CERTIFICATE OF APPROPRIATENESS

Property: 1512 South Blvd, Lot 2, Block 4, Edgemont Subdivision in Boulevard Oaks Historic District, 6,824sq ft two story single family residence with detached guest quarters. situated on a **21,784** square foot (116.75 'x 186.5') corner lot

Proposal: Alteration – Addition

Current Revision:

CURRENT PROPOSED

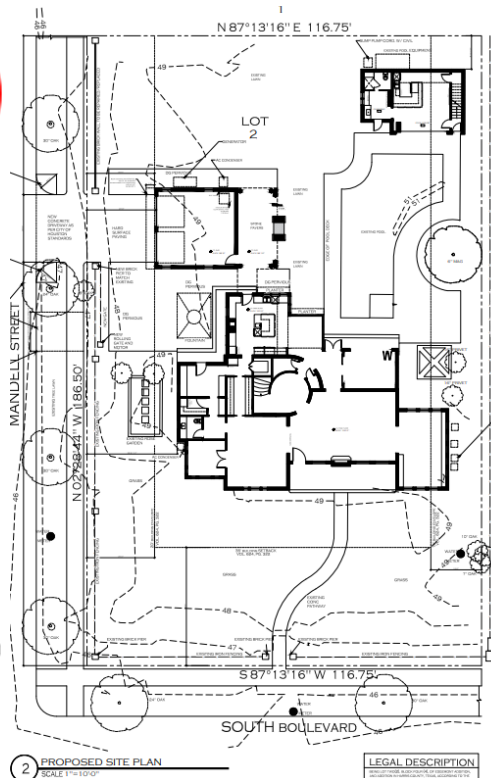
- **Garage Roof:** change west elevation roof from hipped with shed dormer to a clipped gable (see page 23) change window dimensions in previous dormer, remove street facing dormer, and increase size of north and south elevation dormers.

CURRENT PROPOSED

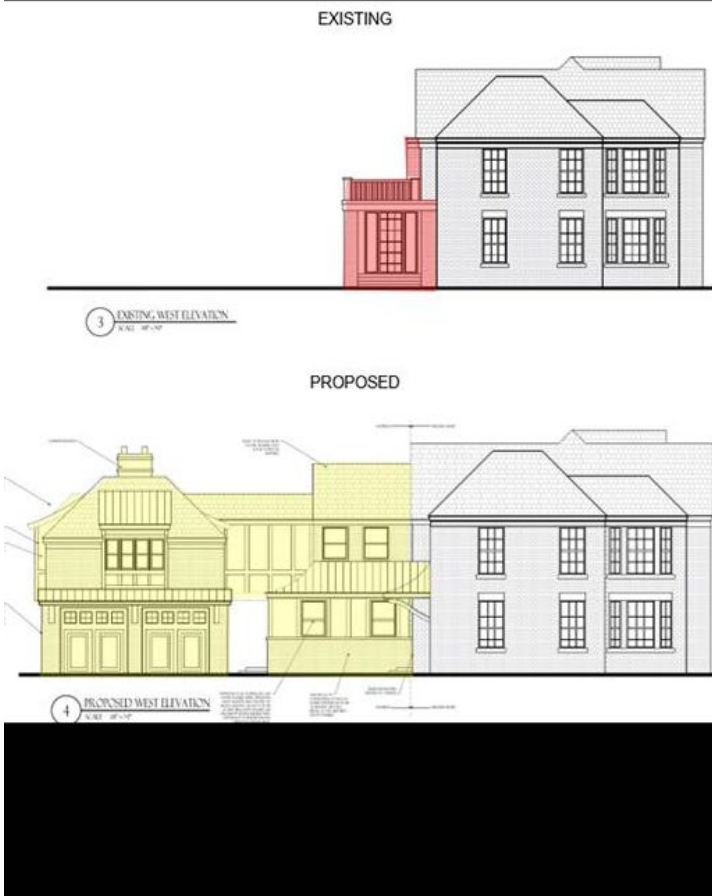
- **Rear Elevation:** keep 2-windows originally proposed to be removed, but current proposal only changes location on existing non-historic addition. Delete French balconies with tall, paired windows at L2 Carriage House east side. Add built-in BBQ at north end of Carriage House open porch.

PROPOSED WEST ELEVATION

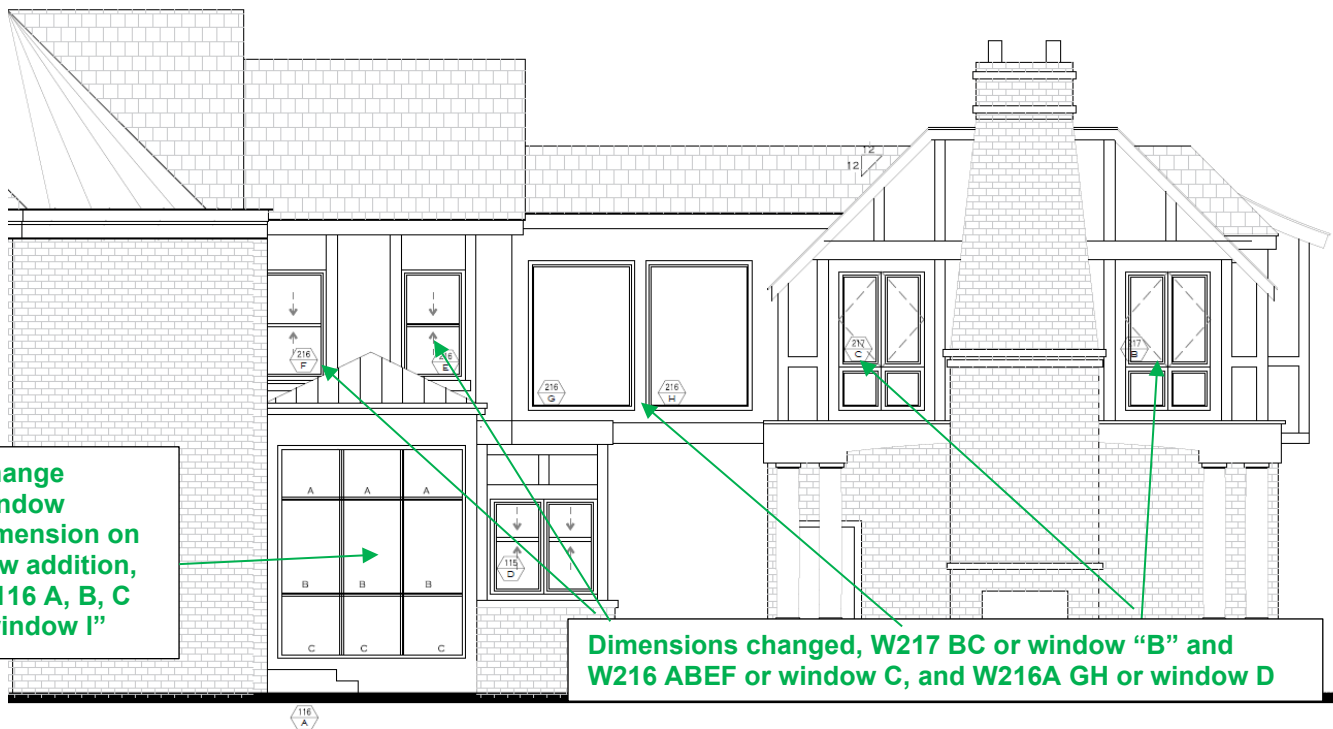
WINDOW KEY OF CHANGES IN NEW PROPOSAL:

Dimensions changed, 221 A or window "E"

Change window dimension on new addition, 115 A, B, C, D or "window F"

Change window dimension on new addition, W116 A, B, C "window I"

PROPOSED EAST ELEVATION (INTERIOR PROPERTY LINE – not seen from street)

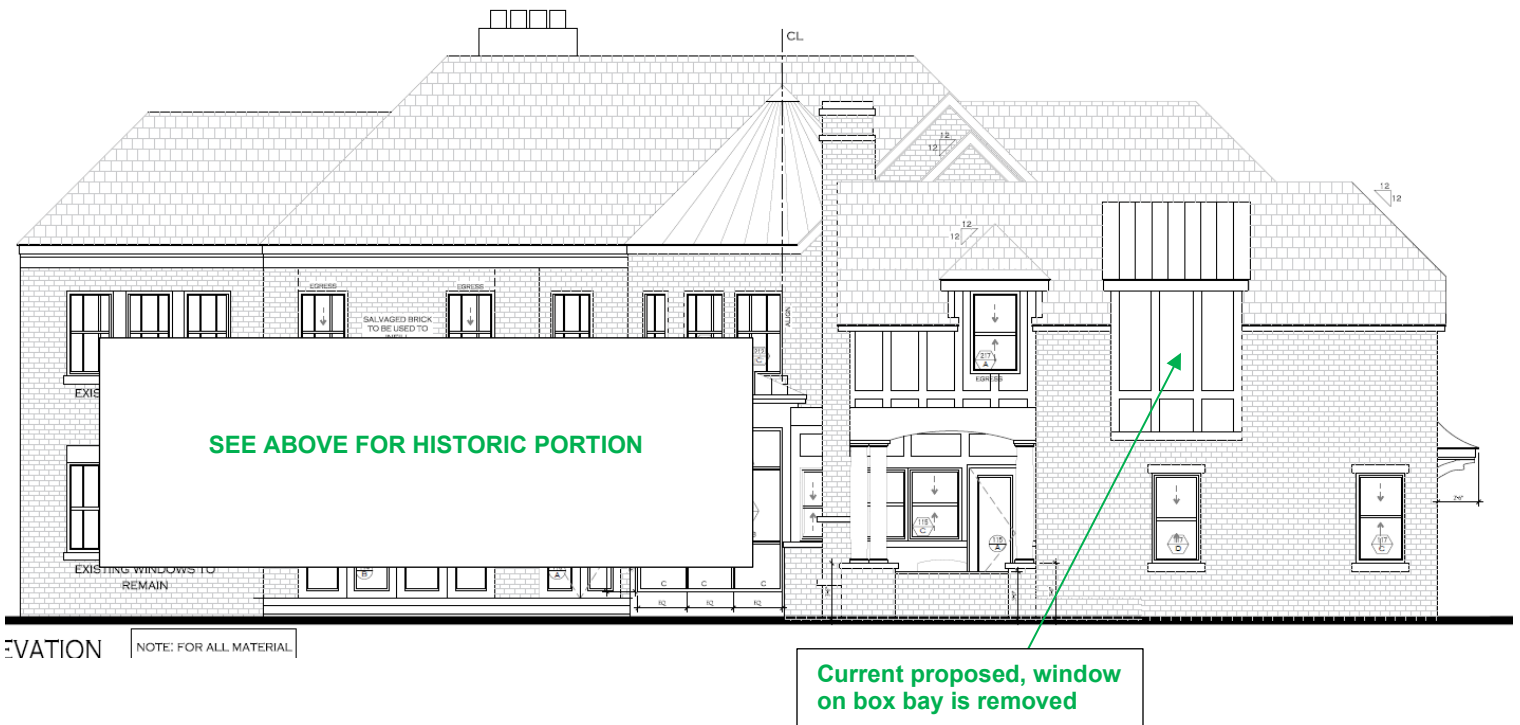
Dimensions changed, W217 BC or window "B" and W216 ABEF or window C, and W216A GH or window D
